Access Compliance Report

Public Rights-of-Way

(Curb Ramps)

Intersection ID: 3964	Main Street: GALLOWAY_RD	Cross Street: PARKLEIGH_DR	Location:	E
ADA ID: 11D728BCF47E	Ramp Type: PerpDiag	Initial Pass/Fail: Fail	Overall Compliance: No	Severity Score: 35

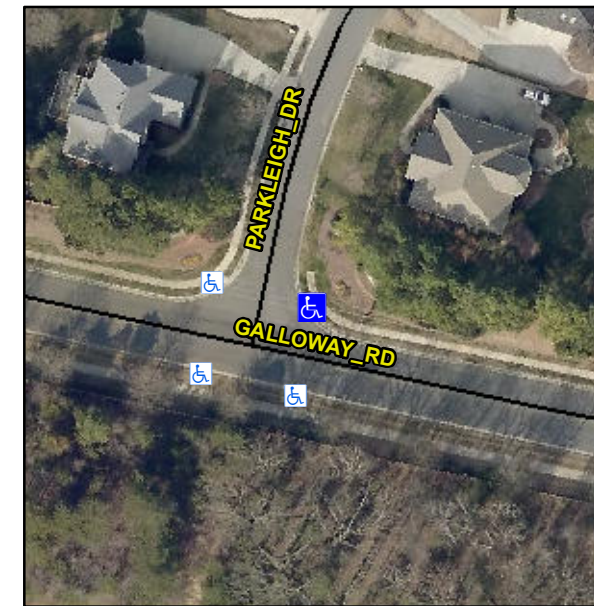
R304.5.1, R304.2.2, R304.5.3

Compliance	Description	Data	Compliance	Description	Data
N/A	Ramp Length (in)	47.0	No	Ramp Slope (%)	14.1
No	Ramp Width (in)	42.0	No	Ramp XSlope (%)	3.2
N/A	Flare Type LT	N/A	N/A	Flare Type RT	N/A
N/A	Flare Slope LT (%)	N/A	N/A	Flare Slope RT (%)	N/A
N/A	Flare Traversable LT?	N/A	N/A	Flare Traversable RT?	N/A
N/A	Landing Length (in)	N/A	N/A	DWS Provided?	N/A
N/A	Landing Width (in)	N/A	N/A	DWS Contrast?	N/A
N/A	Landing Slope (%)	N/A	N/A	DWS Length (in)	N/A
N/A	Landing X Slope (%)	N/A	N/A	DWS Full Width?	N/A
N/A	Landing Curb? (Y/N)	N/A	N/A	DWS Offset (in)	N/A
N/A	Shared Landing?	N/A			
N/A	Gutter Ponding?	N/A	N/A	Gutter Slope (%)	N/A
N/A	Gutter Lip Ht (in)	N/A	N/A	Gutter X Slope (%)	N/A
N/A	Painted X Walk1?	No	N/A	Painted X Walk2?	No
	X Walk 1 Direction	To NW		X Walk 2 Direction	To SW
N/A	X Walk 1 Width (in)	N/A	N/A	X Walk 2 Width (in)	N/A
	X Walk 1 Slope (%)	2.2		X Walk 2 Slope (%)	2.5
	X Walk 1 X Slope (%)	2.4		X Walk 2 X Slope (%)	1.4

Remove & Replace Curb Ramp With Two New Directional Ramps or Equivalent.
